# Rezoning Transportation Analysis

Petition Number: 2019-089

General Location Identifier: 06125112

Date	Description
08-21-2019	First Review
10-16-2019	Second Review

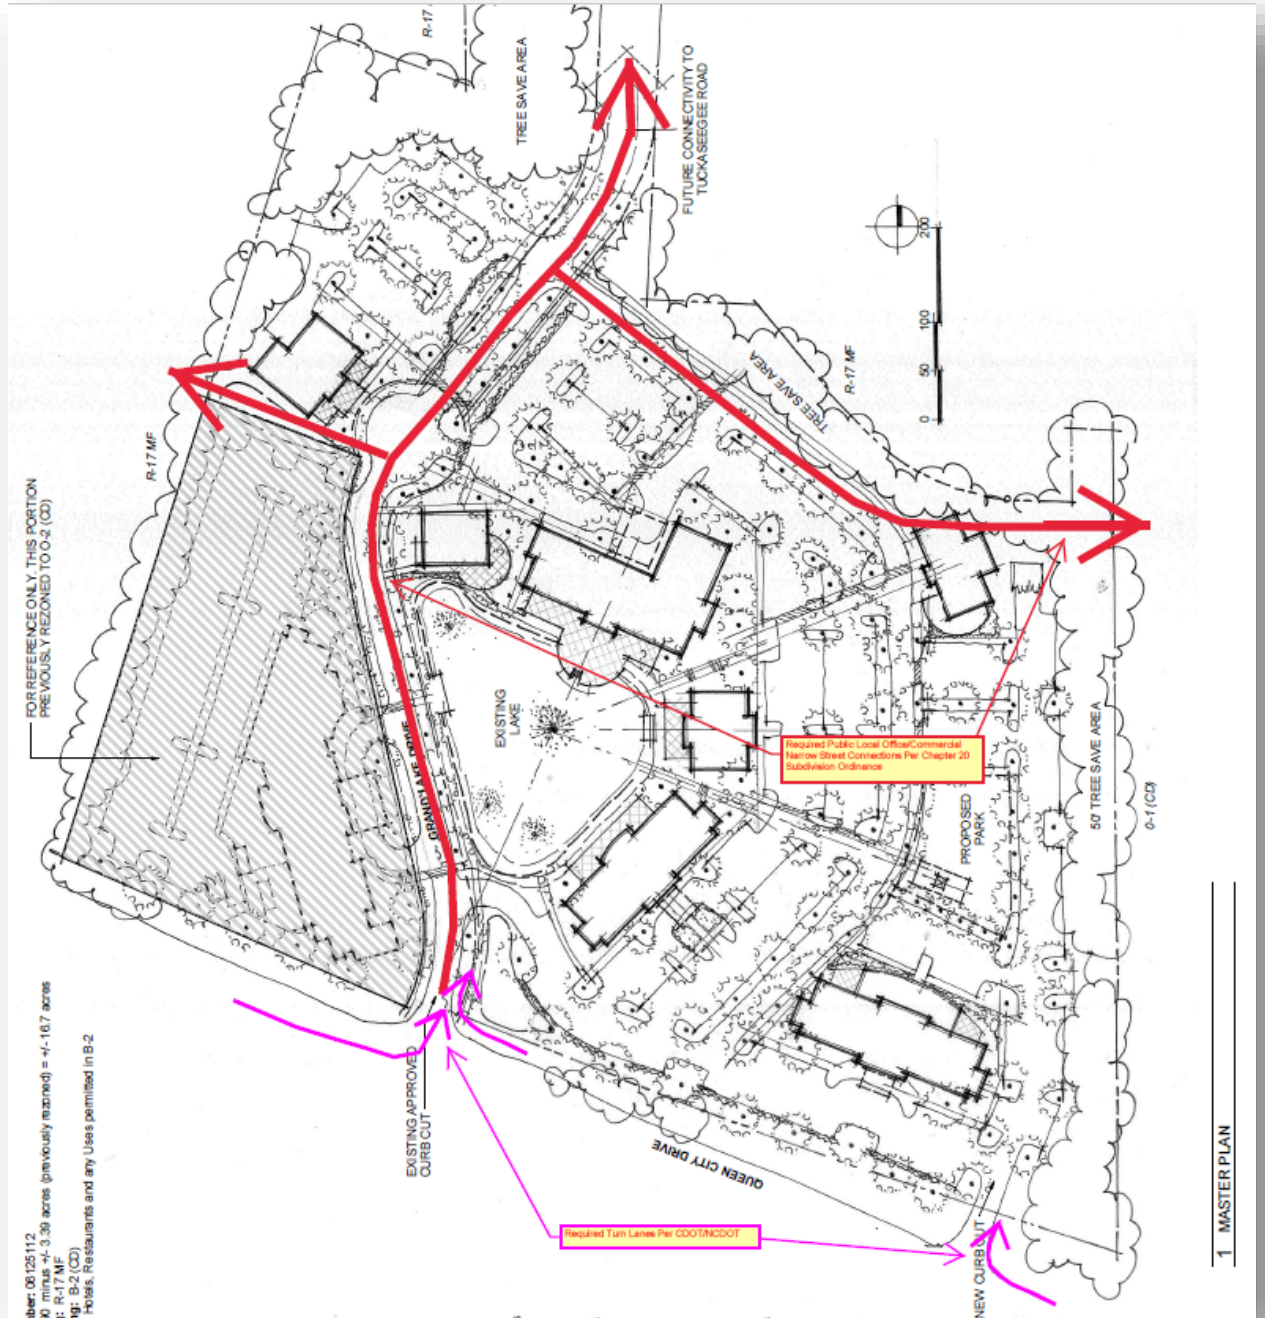
- a. **Road Name (Queens City Drive):** Location of curb and gutter needs to be located 19.0' as measured from the street's existing centerline (to accommodate 3-11' travel lanes). The site plan should show the curb and gutter labeled and dimensioned from the centerline for each road.
2. **Traffic Study** A Traffic Impact Study is necessary for the complete review of this petition. If during the permitting process the site generates more than 2,500 daily trips, then a traffic study will be required. The site plan for public hearing needs to include all the TIS requirements.

3. The petitioner should revise the site plan and conditional note(s) to commit to dedicate 36' right-of-way from Queen City Dr. Queen City Dr. is designated as an existing major collector street. The site plan should label and dimension the right-of-way from the road's centerline.

4. The petitioner should revise the site plan and conditional note(s) to commit and implement Queen City Dr. as a local collector street section (to accommodate 3-11' travel lanes), including an 8' planting strip and 6' sidewalk along the site's Queen City Dr. frontage.

5. The petitioner should revise the site plan and conditional note(s) to commit and implement a 150' NB Queens City Dr. left turn storage lane on with an appropriate bay taper at Queens City Dr.

6. The petitioner should revise the site plan and conditional note(s) to commit and implement a SB Grand Lake Dr. approach at Queens City Dr. to provide three (3) travel lanes (i.e.: 1-13' receiving lane, 1-11' right turn lane, and 1-11' left turn lane).

7. The petitioner should revise the site plan and conditional note(s) to commit, implement, and label Grand Lake Dr. within the development as a "public" local office/commercial narrow street section (see CLDSM U-04.16). Grand Lake Dr. needs to be constructed to the site's western property line per Chapter 20 of the City Subdivision Ordinance.

8. The petitioner should revise the site plan and conditional note(s) to commit, implement, and label two (2) street stubs connecting to Grand Lake Dr. One (1) "public" street stub to the south connecting to parcel ID 06125108, approximately where the existing Grand Lake Dr. cul-de-sac is located. One (1) "public" street stub to the north connecting Grand Lake Dr. to parcel ID 0612401, approximately at this parcel's northern property line (see exhibit below). Both public street stubs are required by Chapter 20 of the City's Subdivision Ordinance to be constructed to local office/commercial narrow street section standards (see CLDSM U-04.16).

9. The petitioner should revise the site plan to add a note specifying the existing Grand Lake Dr. driveway shall have a minimum 100' driveway stem before the first internal driveway.

10. The petitioner should revise the site plan to add a note specifying the proposed driveway located near the site's northern property line, shall be designated as a RI/RO driveway and constructed with a 100' raised median to restrict turning movements at this driveway. Grand Lake Dr. driveway shall have a minimum 50' driveway stem before the first internal driveway.
